Keri Keri Wind Farm – Response to Submissions (TfNSW)

Amber Organisation has been engaged to assist with response to agency advice received from Transport for NSW (dated 11 March 2026) related to Keri Keri Wind Farm. Table 1 provides a summary of the comments which have been addressed herein.

Table 1: TfNSW Response to Submissions

DRAWN: OM
 DATE: 20/05/2026
 DWG NO: 1652 RA01C
 SCALE at A3: 1:1000

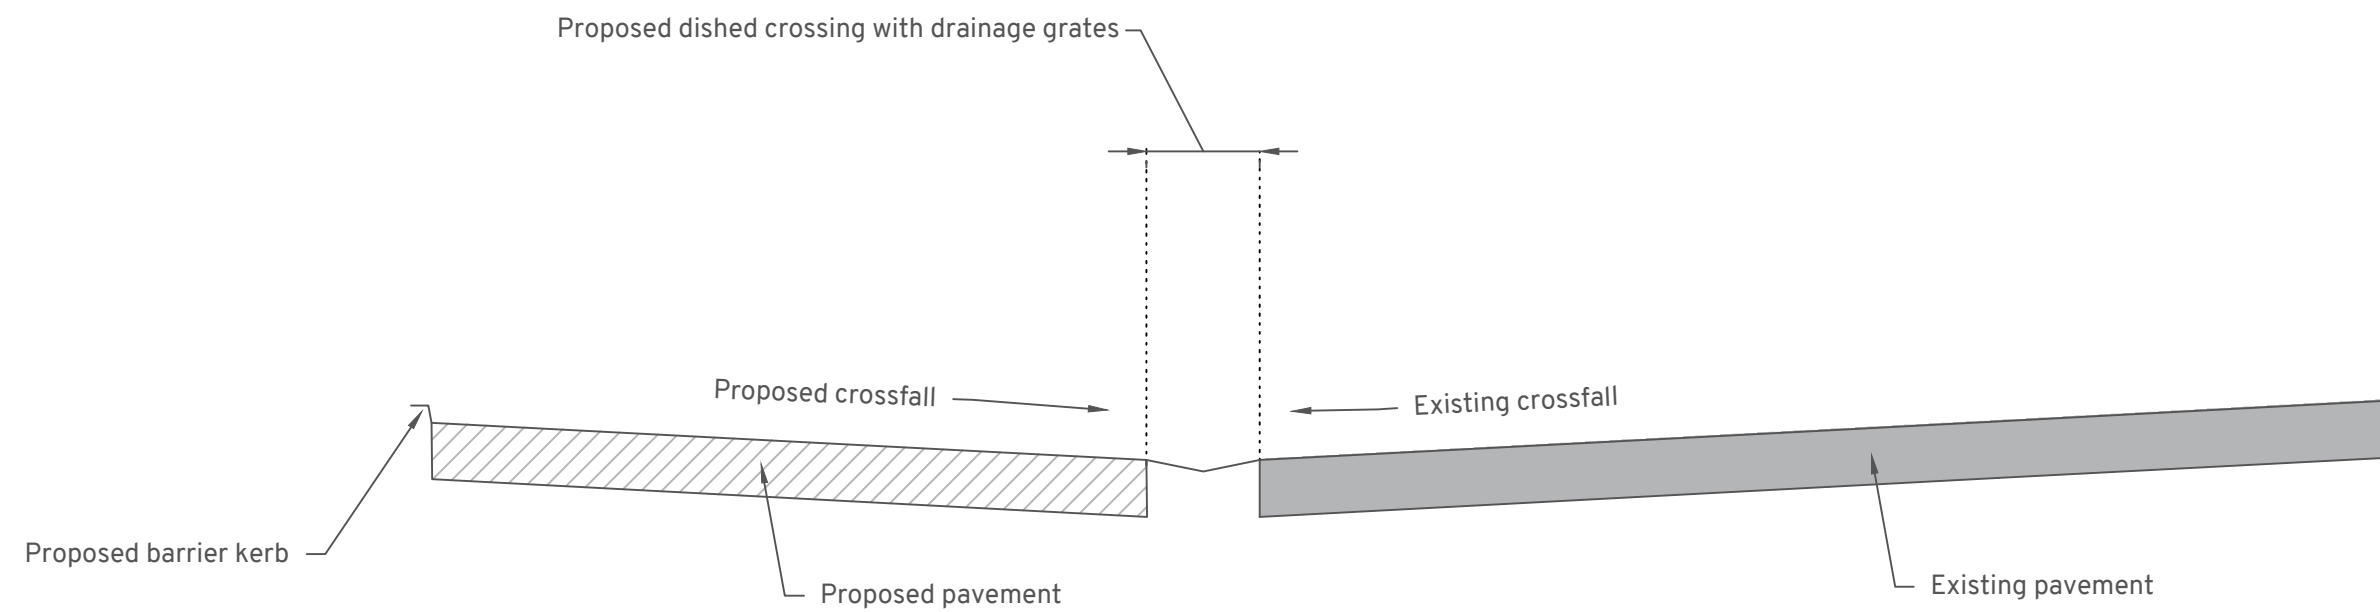
3g	<u>g. Revision D Civil Design RJ Andrews SPA - Sturt Highway at Euston</u> - TfNSW requires a strategic concept hardstand design prior to determination, that includes the kerb replacement, existing drainage and other infrastructure checks that will impact on the scope of the road upgrades/modifications.	Strategic concept design for this intersection is provided in Appendix A (Sheets 08-10). The design includes a dish crossing with trafficable grates to facilitate movements onto the hardstand area.
3h	<u>h. Revision D Civil Design RJ Andrews SPA - Parking Bay @86m near Balranald (Left turn into Duryea Street)</u> - The proposed parking bay is adjacent to the left turn lane into Duryea Street and private service centre. It is unsealed and poses safety concerns given the number of conflict points at this location. Is there another viable location with reduced conflict points that can be utilised/constructed?	This parking bay is no longer proposed to be utilised. An alternative location where OSOM vehicles would be able to pull over if required is available in Balranald along Sturt Highway (Market Street) adjacent to Balranald Lions Park, as outlined on page 49 of the RJA report (Revision 03).

Keri Keri Road/Sturt Highway
Concept Design - Staggered Intersection With BAL / CHR(s)
Keri Keri Wind Farm

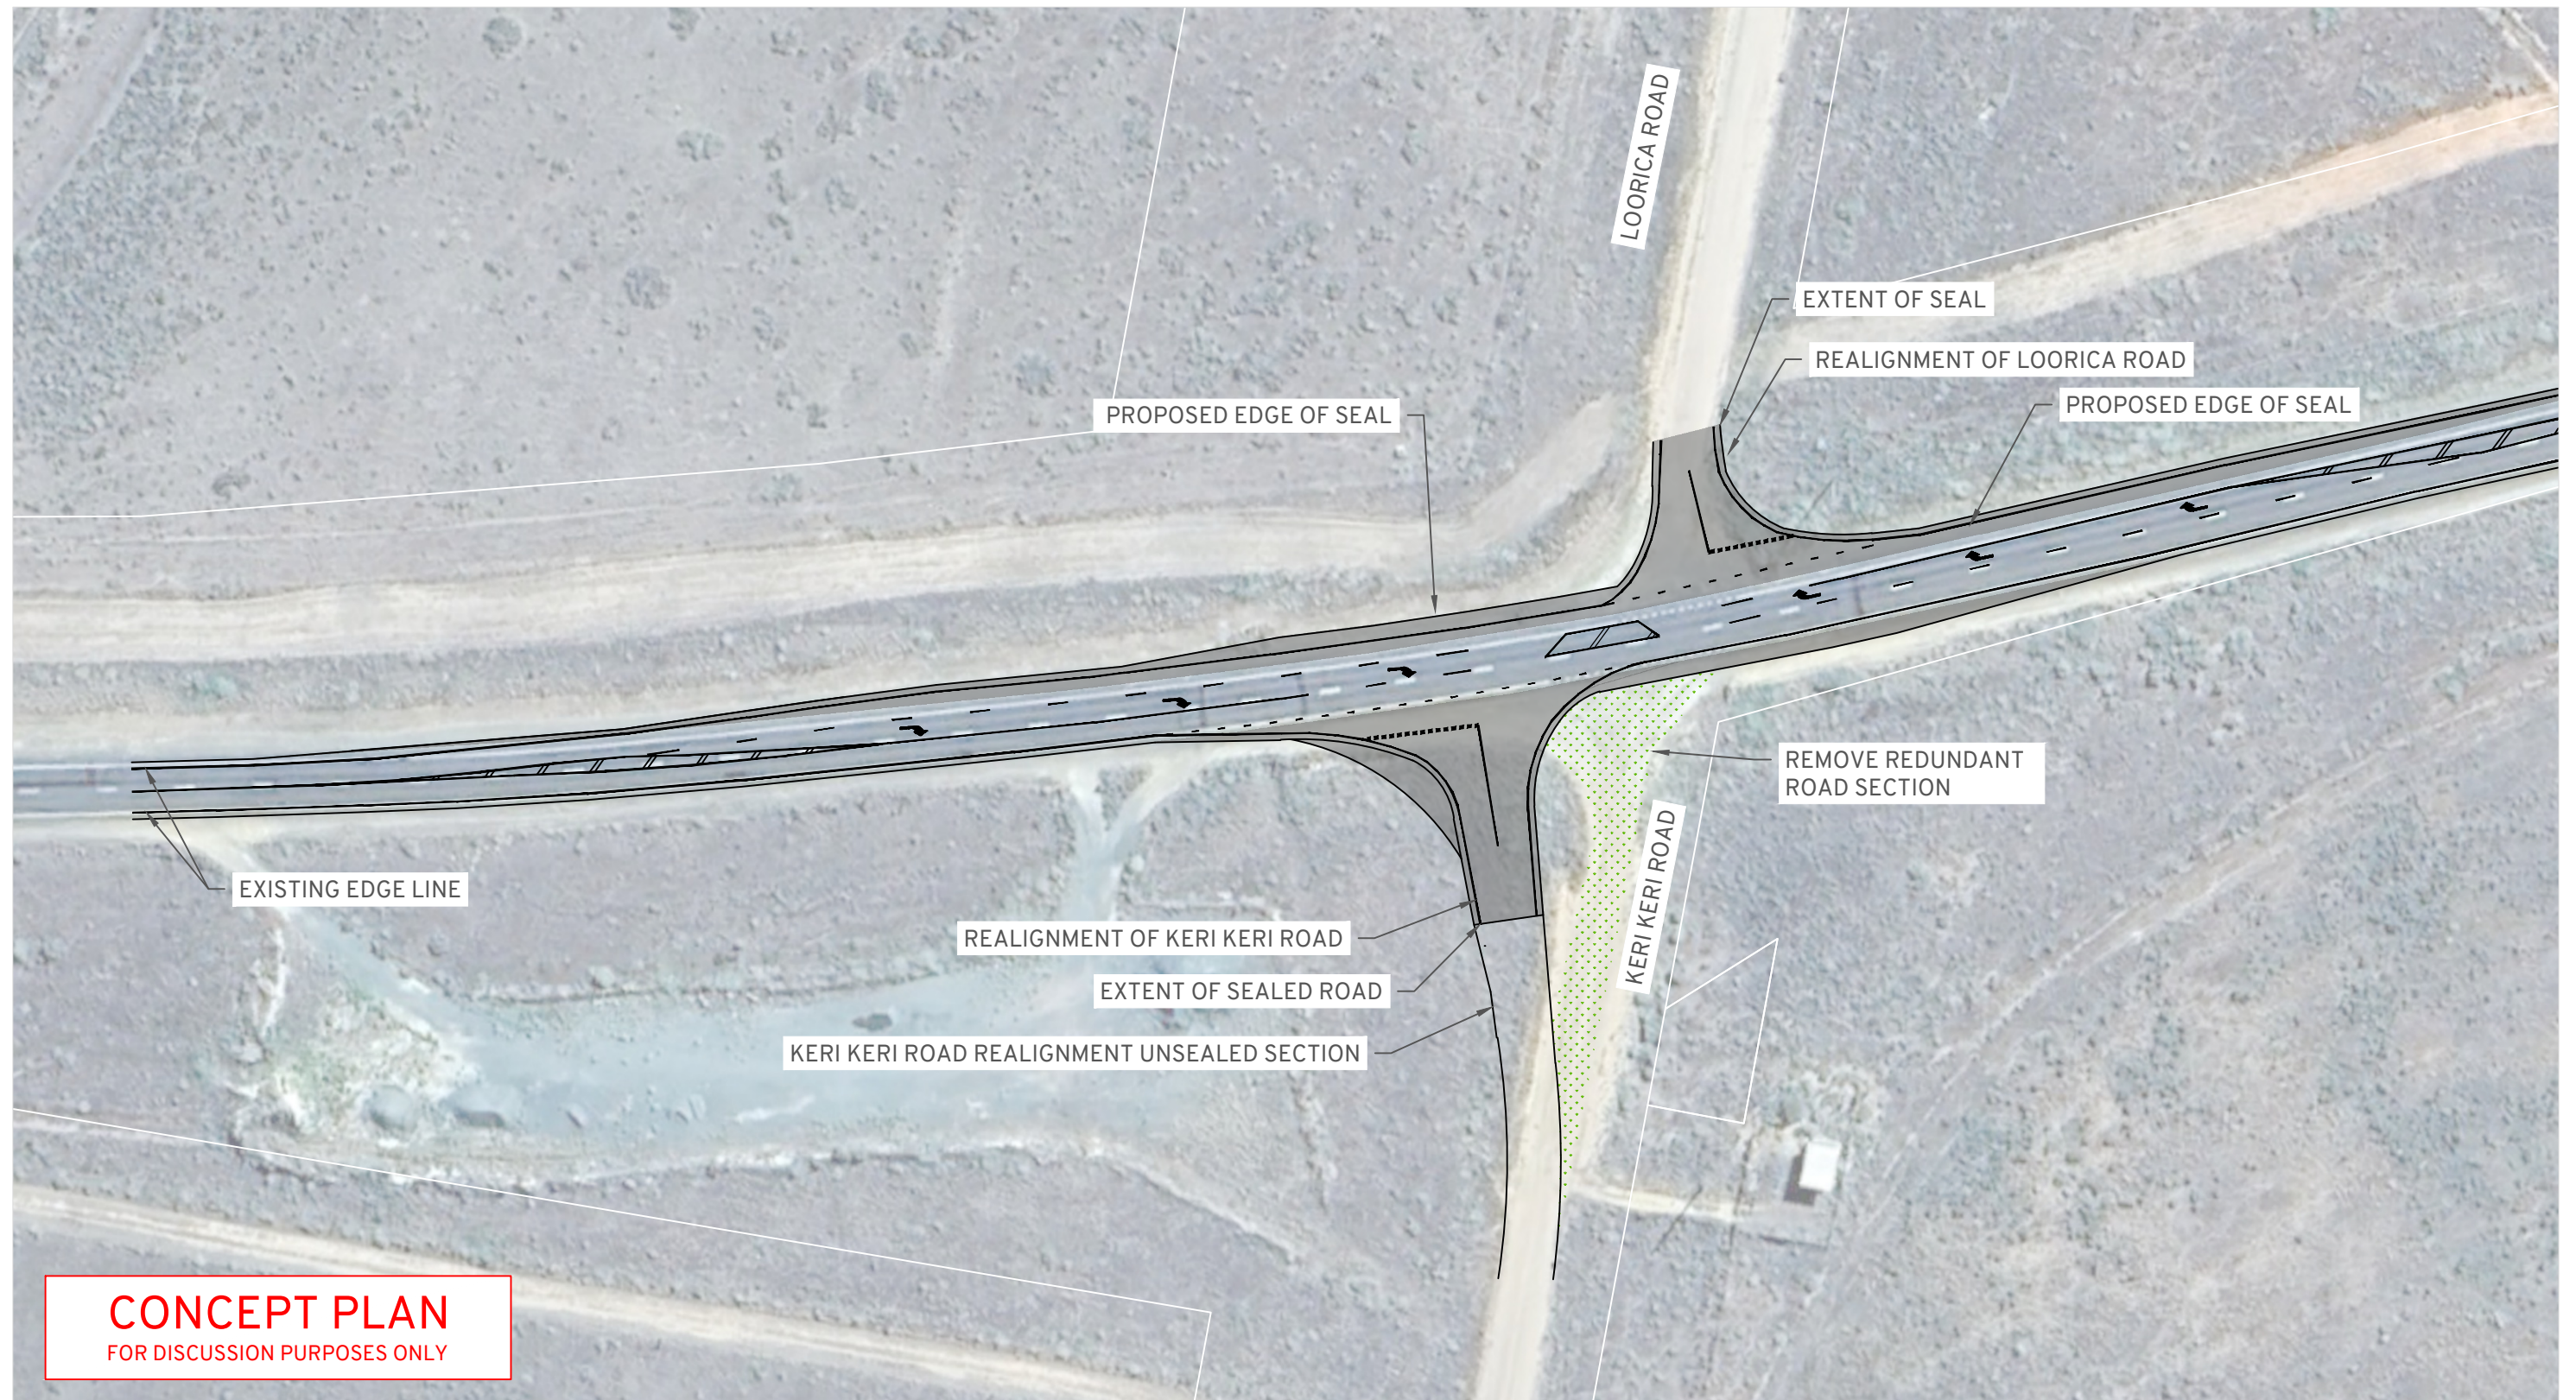
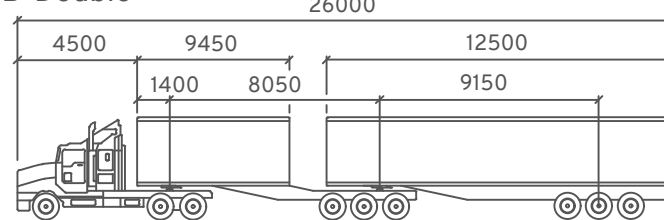
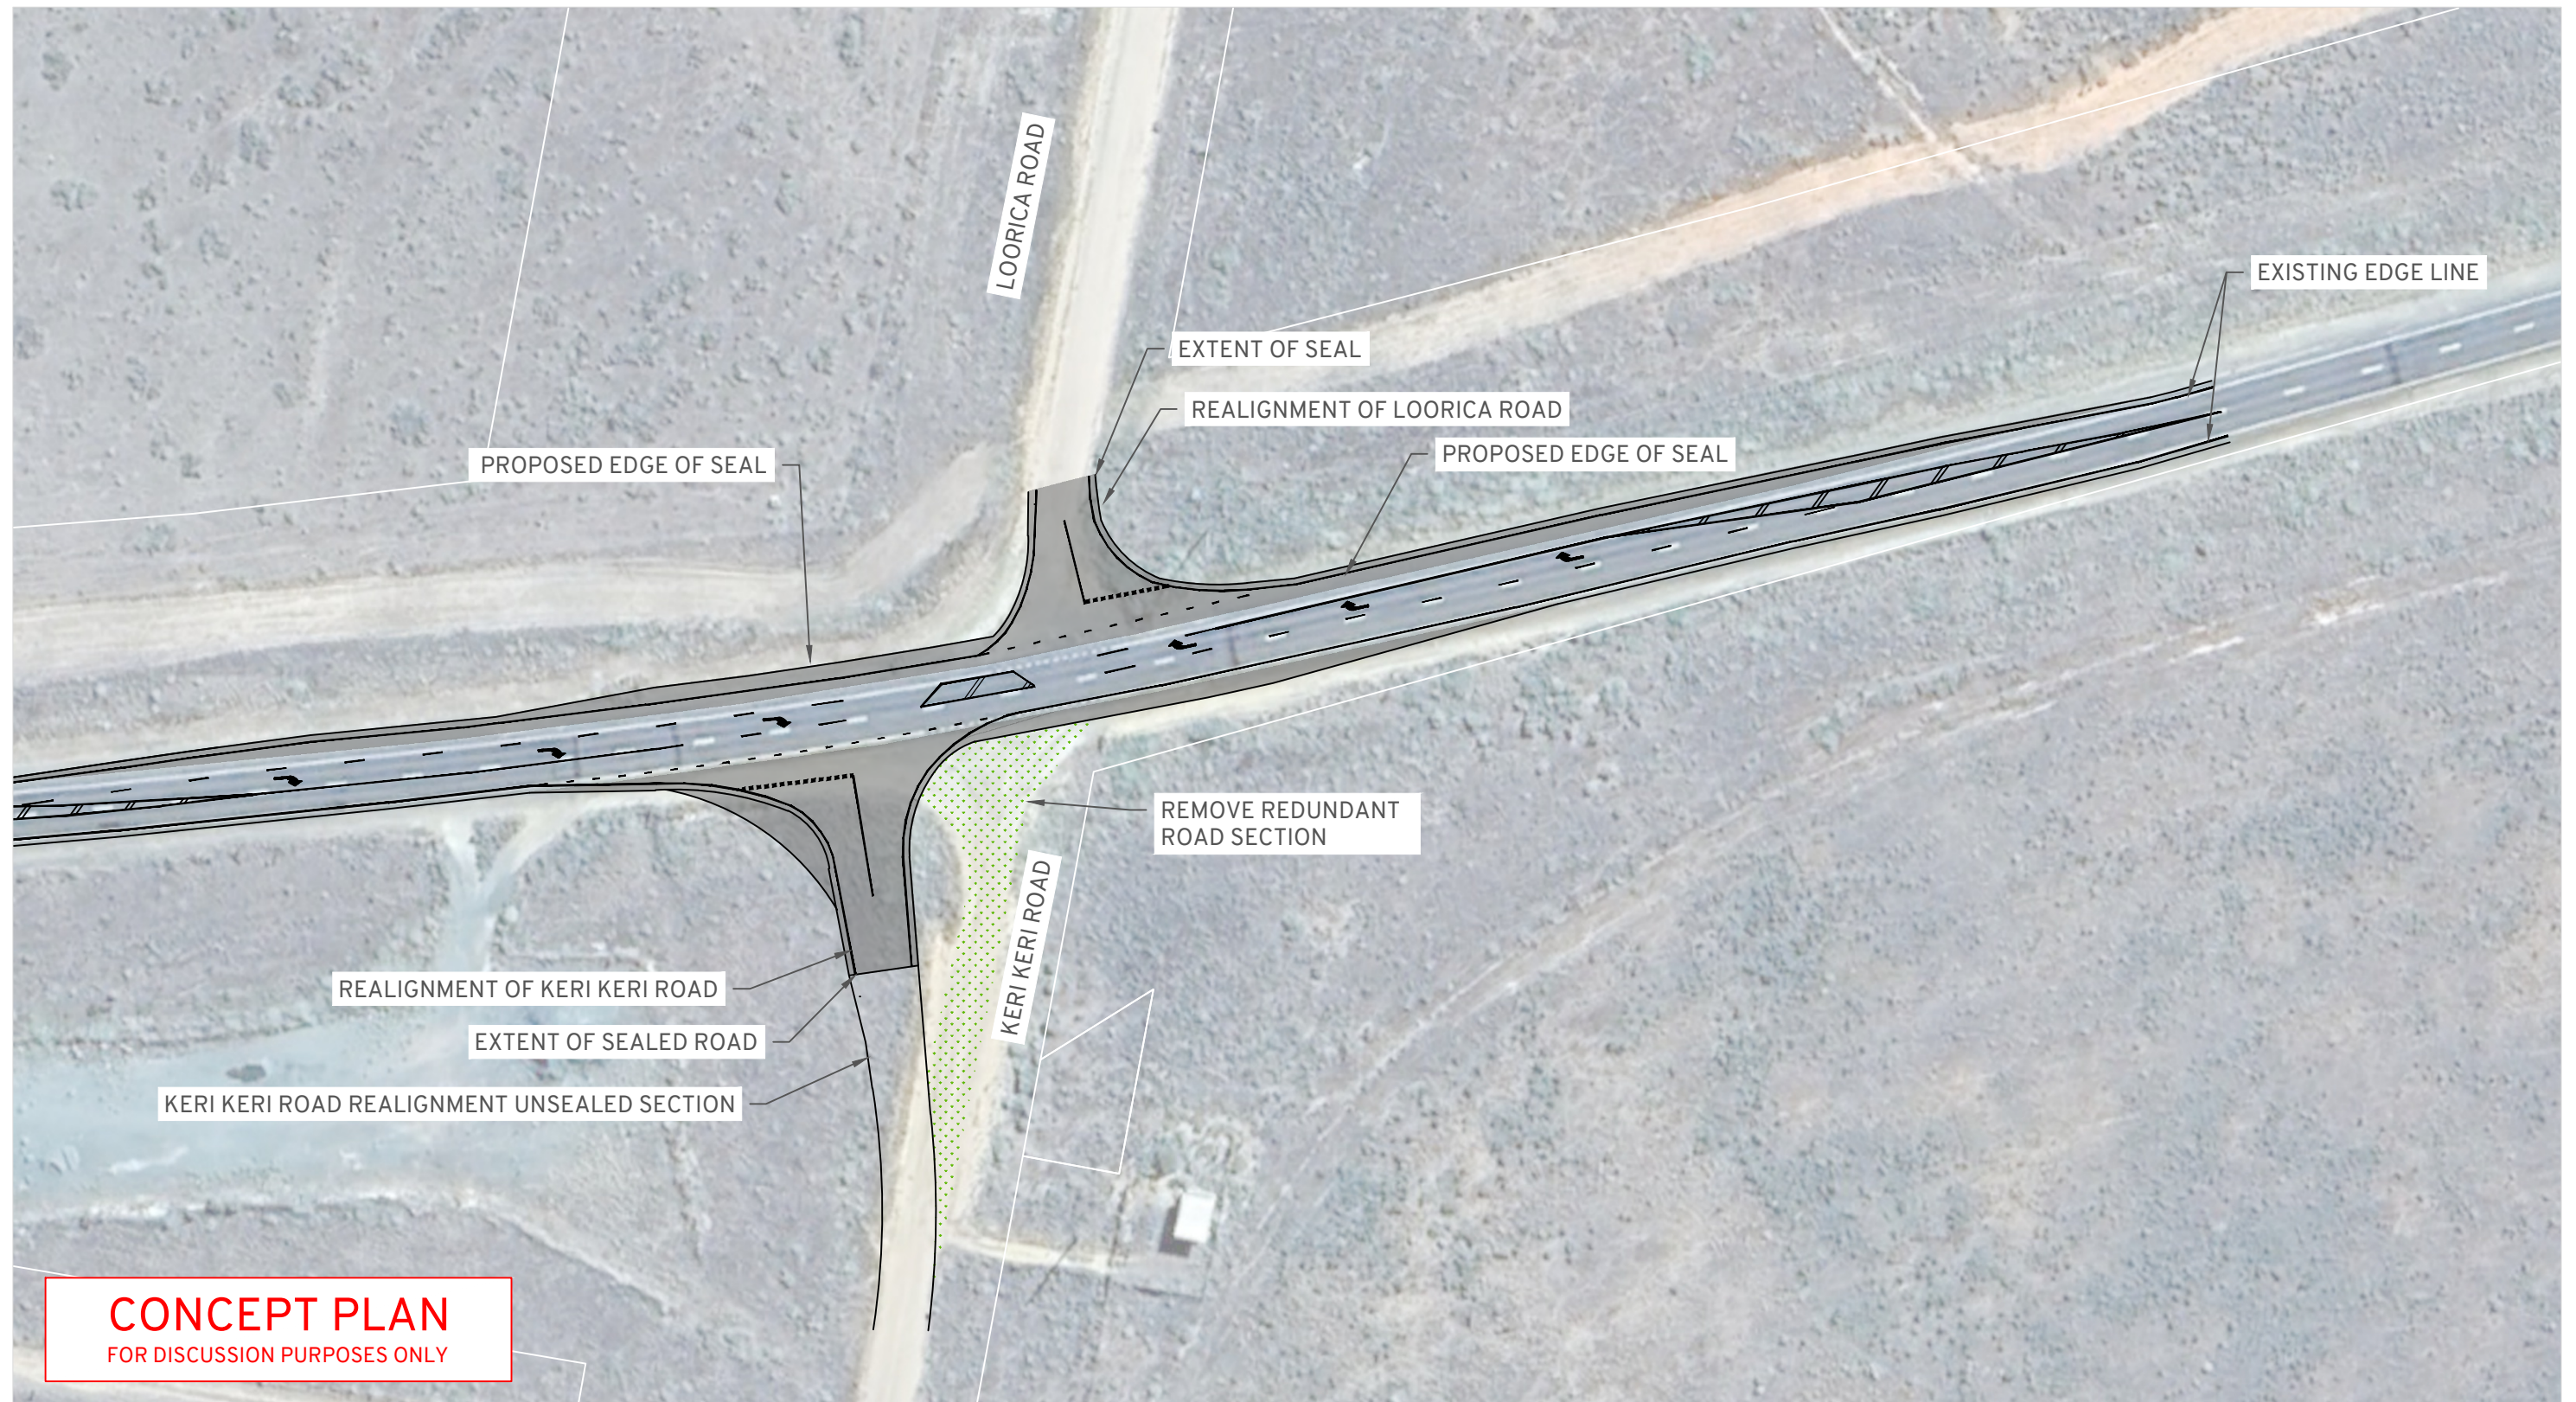
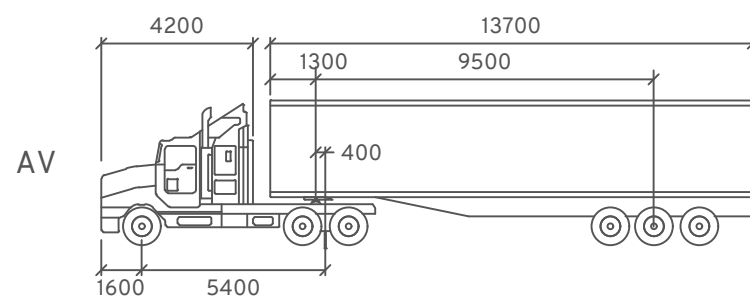
3j	<u>j. Revision D, Civil Design, 21012CAD003 Figure 5 –</u> - TfNSW preference is to maintain the current intersection configuration with medians and kerb and channel. Please replace the barrier kerb with a roll-over kerb to facilitate movements onto the hardstand. Drainage pits will need to be assessed and made trafficable as required. - Where the raised island is proposed to be removed, TfNSW's preference is to retain this island and make parts of or the whole length trafficable.	Revised strategic concept design for this intersection is provided in Appendix A (Sheets 04-07). The design includes a dished crossing with trafficable grates to facilitate movements onto the hardstand area, as well as strengthening of the impacted traffic island.
3k/l	<u>k. Revision D, Civil Design, 21012CAD003 Figure 9 - Keri Keri Road</u> - The intersection of Sturt Highway, Keri Keri Road and Loorica Road is a four-way intersection. This arrangement is undesirable, as road users may not perceive that they are approaching an intersection and may continue through, increasing the likelihood of a side-impact crash. Austroads Guide to Road Design provides guidance on modifying four-way intersections to a staggered T intersection to mitigate this risk. Due to this development, traffic on Keri Keri Road will increase significantly, increasing the likelihood of this crash type. <u>l. Revision D, Civil Design 21012CAD003 Figure 9 - Keri Keri Road</u> - The intersection angle is 70 degrees, which is allowable by the standards; however, it is the absolute minimum. Is there an opportunity to better align Keri Keri Road with the Sturt Highway?	Revised strategic concept design for this intersection is provided in Appendix C. The design includes realignment of the minor road approaches to form 90-degree staggered T-intersections with BAL and CHR(s) treatments for each approach.
